**Entwürfe der EU-Kommission vom 6. Oktober 2020
Stellungnahme des Herstellerverbandes EFIC ^[2]
vom 3. November 2020**

Consultations on updated EU rules on ecodesign and energy labelling EFIC feedback

3 November 2020

Commission Regulation (EU) .../.... of XXX amending Regulation (EU) 2019/ 2020

System light source <> surrounding product furniture = surrounding product

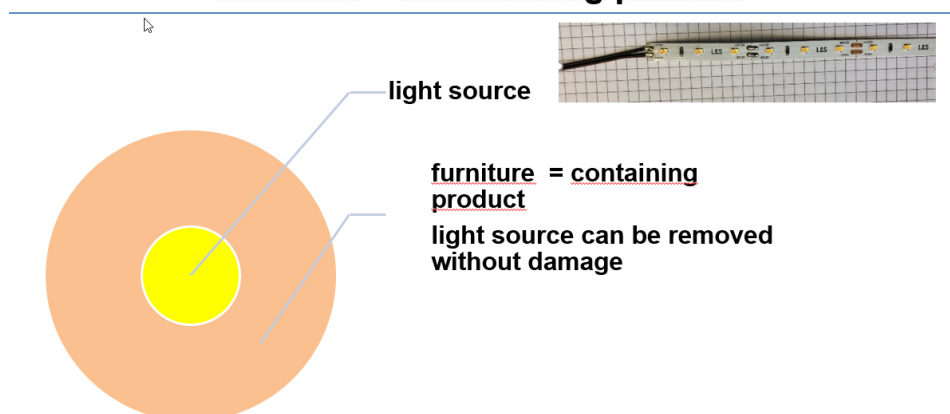
The proposed text clarifies from our point of view that furniture with light sources contained in it is always a "containing product".

System light source <> surrounding product luminaires = containing product

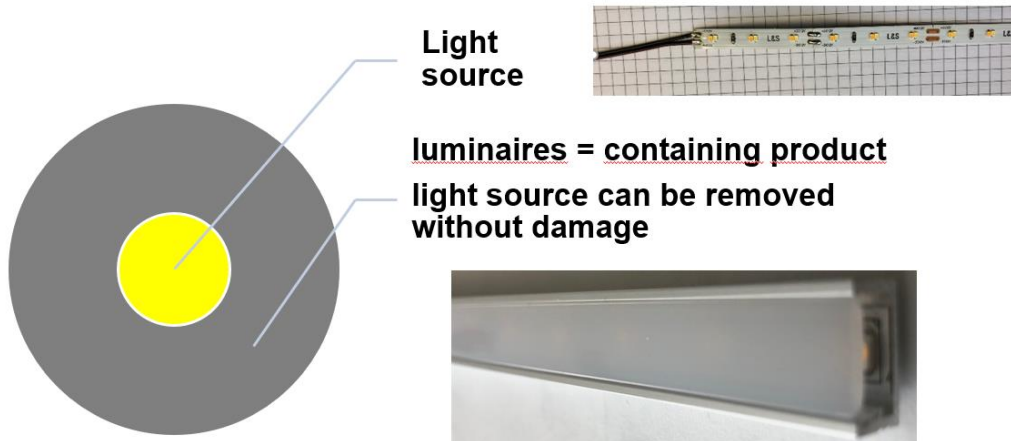
Luminaires are addressed in the same paragraph and under the above conditions, they may also be a "containing product".

As a logical consequence, this would mean that furniture with a luminaire (= containing product) is not a "containing product".
